Access Compliance Report

Public Rights-of-Way

(Pedestrian Signals)

Intersection ID: N/A	Main Street:	Cross Street: N/A	Location: N/A
ADA ID: D79B8B1A6FE1	Signal Type: Two Push Buttons-APS	Overall Compliance: No	Severity Score: BTN 1:N/A BTN 2: N/A No BTN: N/A
Codes/Mitigation Info/Possible Solution		Field Measurements/Component Compliance

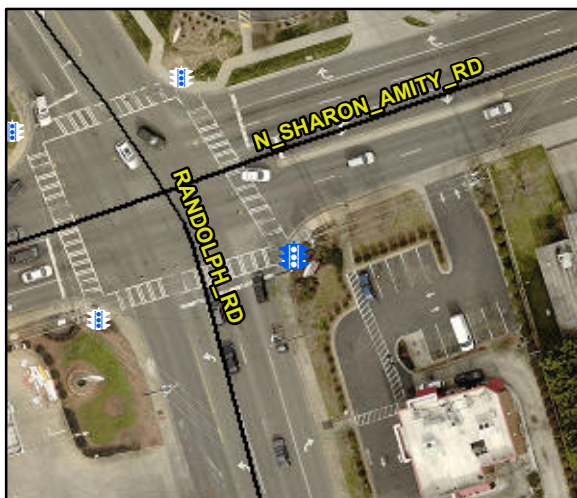
Possible Solutions: Replace Signal Push Button With APS Button on New Post. Remove & Relocate Sign.

PROW/ADA: TMUTCD 4e.08, R404.2, R406.2, , R404.3

Compliance	Description	Data	Compliance	Description	Data
	Button Count	Button2	N/A	Distant to Additional Button (in)	N/A
	Additional Button Present?	No		Additional Button ID	N/A
N/A	Signal Buttons Required?	N/A	N/A	Additional Ped Posts Required	N/A
	How Many Ped Street Xings?	2		Located In An Island/Median?	No
N/A	B 1 Sign Present?	Yes	N/A	B 2 Sign Present?	Yes
Yes	B 1 Sign Purpose?	Yes	Yes	B 2 Sign Purpose?	Yes
Yes	B 1 Sign Lettering & Contrast?	Yes	Yes	B 2 Sign Lettering & Contrast?	Yes
Yes	B 1 Parallel To XWalk?	Yes	Yes	B 2 Parallel To XWalk?	Yes
Yes	B 1 PAR to Button?	Yes	Yes	B 2 PAR to Button?	Yes
Yes	B 1 PAR to XWalk?	Yes	Yes	B 2 PAR to XWalk?	Yes
Yes	B 1 Clear Floor Space?	Yes	Yes	B 2 Clear Floor Space?	Yes
N/A	B 1 FWD Approach?	Yes	N/A	B 2 FWD Approach?	Yes
N/A	B 1 FWD Approach Constrained?	No	N/A	B 2 FWD Approach Constrained?	No
No	B 1 FWD Approach Reach (in)	7.0	No	B 2 FWD Approach Reach (in)	31.0

N/A	B 1 FWD Approach Width (in)	N/A	N/A	B 2 FWD Approach Width (in)	N/A
N/A	B 1 FWD Approach Obstruction?	Yes	N/A	B 2 FWD Approach Obstruction?	Yes
N/A	B 1 FWD Approach Obstruction Dist (in)	1.0	N/A	B 2 FWD Approach ObstructionDist (in)	28.0
N/A	B 1 PARA Approach?	Yes	N/A	B 2 PARA Approach?	Yes
N/A	B 1 PARA Approach Constrained?	No	N/A	B 2 PARA Approach Constrained?	No
Yes	B 1 PARA Approach Reach (in)	5.0	Yes	B 2 PARA Approach Reach (in)	8.0
N/A	B 1 PARA Approach Width (in)	N/A	N/A	B 2 PARA Approach Width (in)	N/A
N/A	B 1 PARA Approach Obstruction?	Yes	N/A	B 2 PARA Approach Obstruction?	Yes
N/A	B 1 PARA Approach Obstruction Dist (in)	1.0	N/A	B 2 PARA Approach ObstructionDist (in)	2.0
Yes	B 1 Clear Floor Space Slope (%)	1.9	No	B 2 Clear Floor Space Slope (%)	2.6
No	B 1 Clear Floor Space XSlope (%)	6.0	No	B 2 Clear Floor Space XSlope (%)	7.8
N/A	B 1 PAR Slope (%)	1.8	N/A	B 2 PAR Slope (%)	1.3
Yes	B 1 Height (in)	46.0	Yes	B 2 Height (in)	46.0

Yes	B 1 Clear Xing Direction?	ClearlyMarked	Yes	B 2 Clear Xing Direction?	ClearlyMarked
	B 1 Crossing Direction	To NW		B 2 Crossing Direction	To SW
Yes	B 1 DistanceTo XWalk (in)	0.0	Yes	B 2 DistanceTo XWalk (in)	0.0
No	B 1 DistanceTo Curb (in)	74.0	No	B 2 DistanceTo Curb (in)	74.0
Yes	B 1 Diameter (in)	2.0	Yes	B 2 Diameter (in)	2.0
